Set ICOP-6054 COM 3/4 to IRQ 10/11

2003-12-15

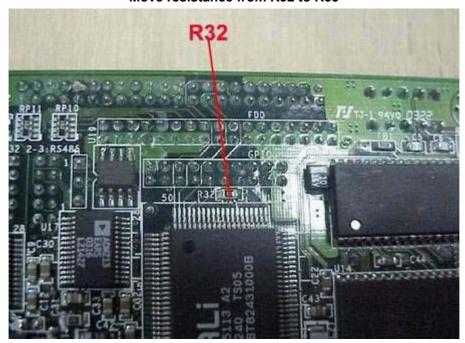
This document will show you how to assign ICOP-6054VE COM 3/4 to IRQ 10 /11 by hardware modification. See the picture:

Move resistance from R34 to R35
